13 VICTORIA PARADE
3 STOREY BRICK
MIXED USE BUILDING

PROPOSED S4.55(8) MODIFICATIONS LIST:

ISSUED FOR S4.55(8) LODGMNT
NOT FOR CONSTRUCTION

DRAWING TITLE			PROJECT
SIXTH FLOOR PLAN			VPM
SCALE	STATUS	NUMBER	REVISION
1 : 100	s4.55 (8)	A1.08	A

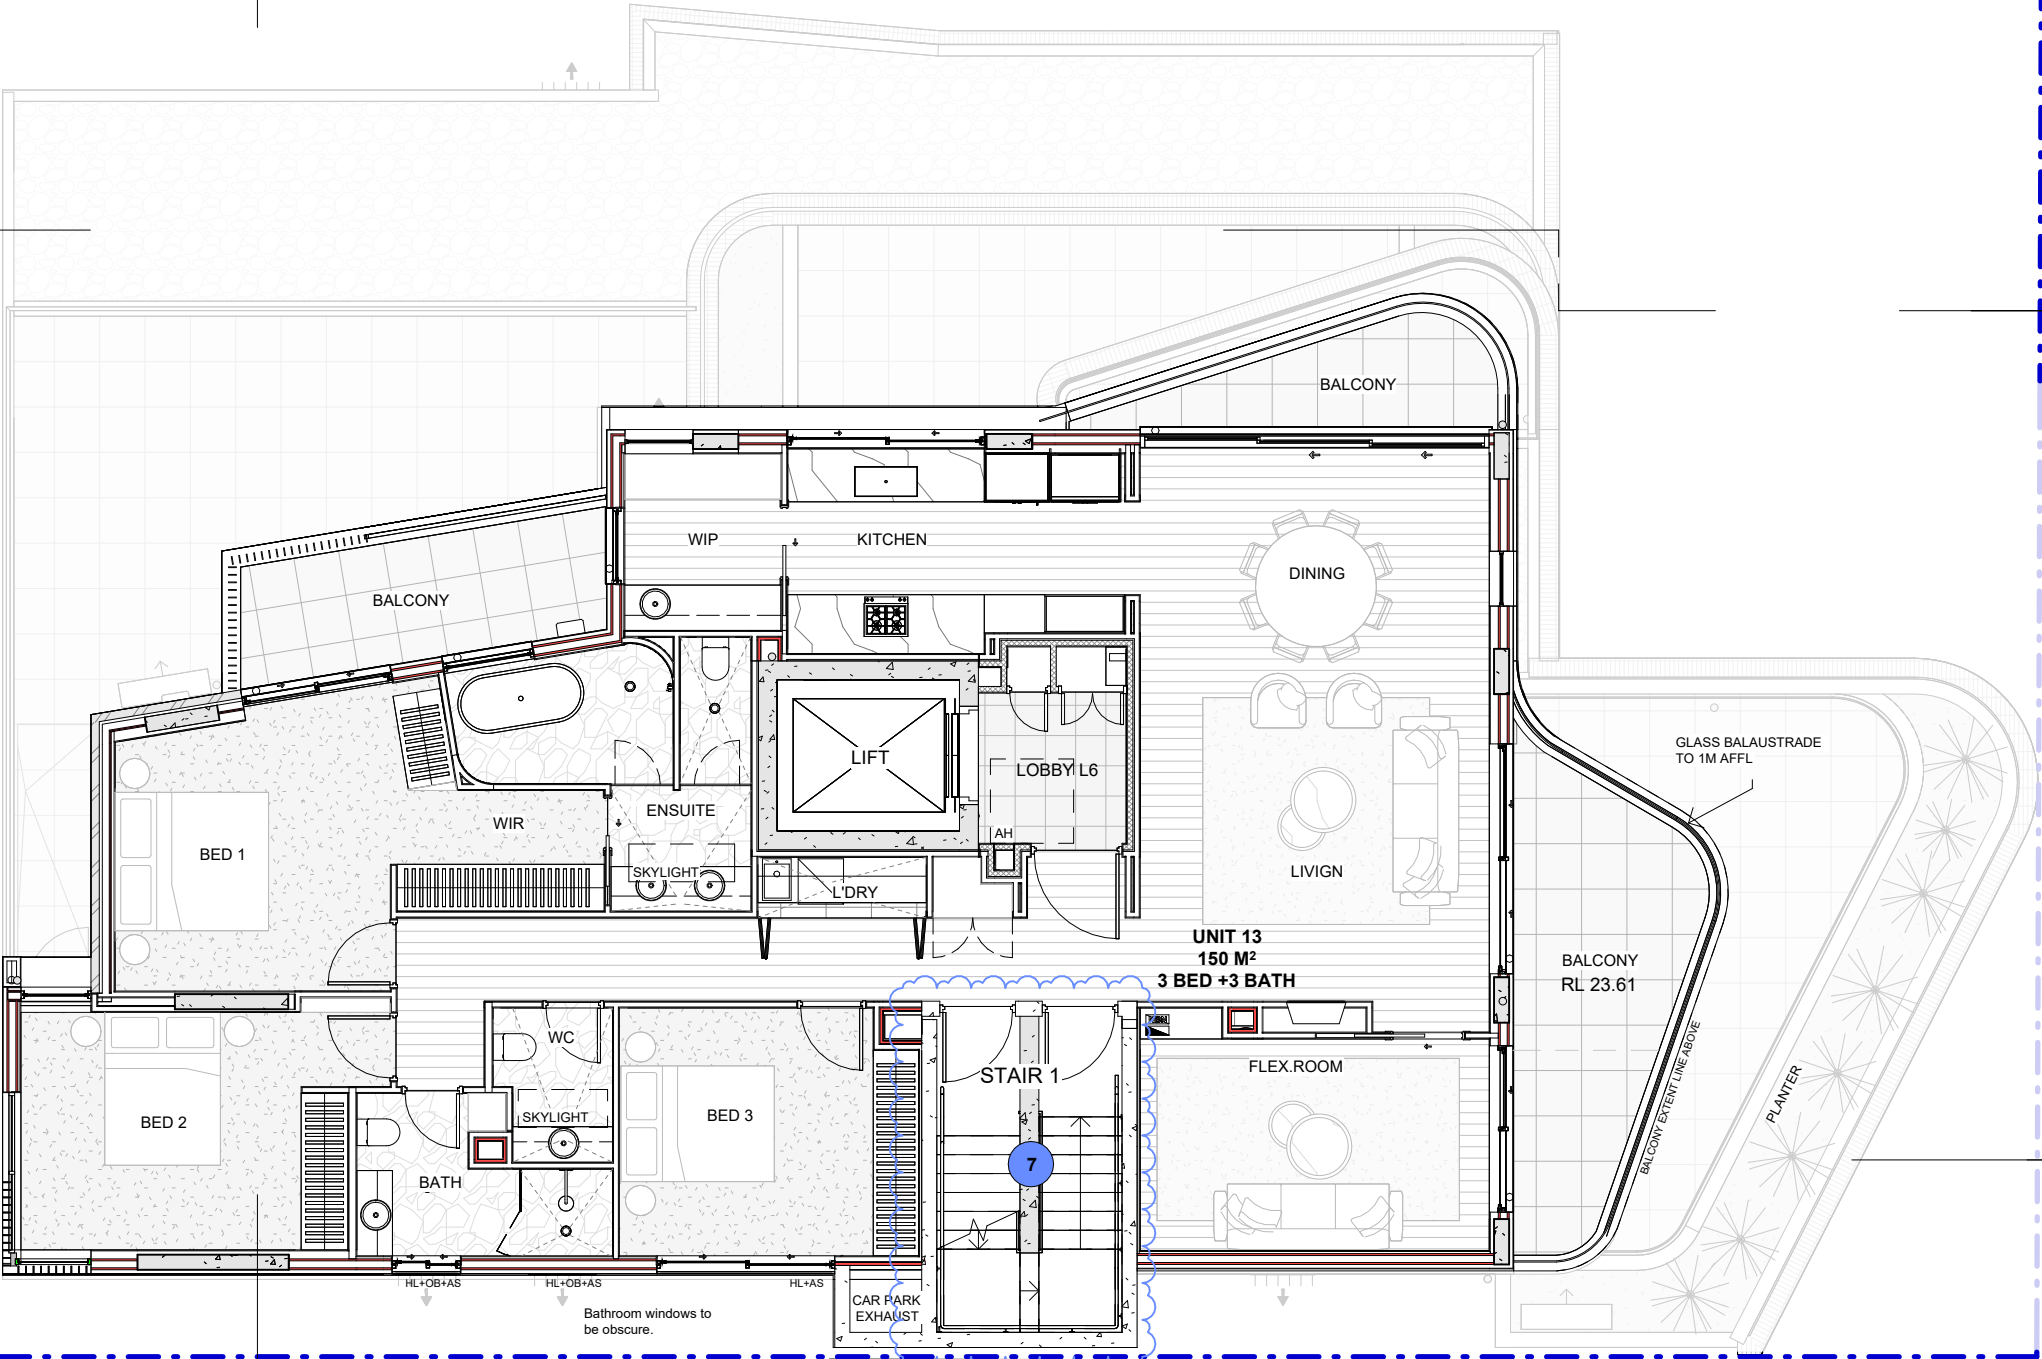
- Retail 1 on Ground floor has been pushed out to enhance the usable area and to suit new columns for balconies above.
- The front facade's angle has been adjusted to enlarge the front balconies and comply with ADG regulations of balcony size.

- Front balconies on level 1 and level 2 were extended to the north east to align with the approved balconies above to avoid looking 'top-heavy' and unbalanced.

- Level 4 brick wall shifted to align with adjacent brick walls.
- Cladding colour proposed to be off-white to visually lighten the bulk of the upper floors.

- Allocation of 1 bicycle space per unit in large storage cages in lieu of separate bicycle parking to satisfy the intention of condition 43D.
- Private roof terrace introduced to improve amenity of unit 14. The glass stair enclosure is not readily visible from the street and has no real impact on privacy, bulk or overshadowing.

- Increase in width of high-light windows to improve ventilation and natural lighting in the bedrooms with no privacy impacts.
- Minor adjustment to the GFA due to the above– still less than LEC approved FSR 3:1.

- Window heads have been lowered to 2.58m to fit services
